Maxtor Corporation
500 McCarthy Boulevard
Milpitas, CA 95035 USA

Subject: SAS driver and receiver electrical characteristics additions

This proposal adds common mode specifications to define differential signal balance, defines common mode transients during mode changes and hot plug events, and defines a receiver common mode tolerance (i.e., rejection) requirement. Revision 2 incorporates changes from SAS PHY working group discussions, changes "common mode transients" to "transients" to be more general, and replaces the common mode signal component requirement with a transmitter balance requirement. Table and other references are to SAS-r02b. Revision 3 of this proposal corrects minor editorial errors that were in revision 2. Revision 4 includes a change to the Table 23 entry for Physical link rate tolerance at XR to match that in SATA errata 030.

Figure xxa. Transmitter transient test circuit

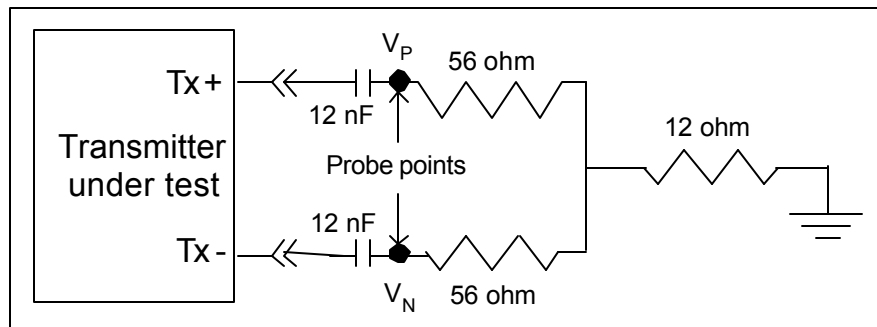
c The coupling capacitor value for AC coupled transmit and receive pairs.
 d The maximum transmitter and receiver transients are measured at nodes V_P and V_N on the test loads shown in figures xxa (for the transmitter) and xxb (for the receiver) during all power state and mode transitions. Test conditions shall include the system power supply ramping at the fastest possible power ramp (up and down).
 e Receivers must tolerate sinusoidal common mode noise components within the peak-to-peak amplitude (V_{cm}) and the frequency range (F_{cm}).

Add the following figures after the table:
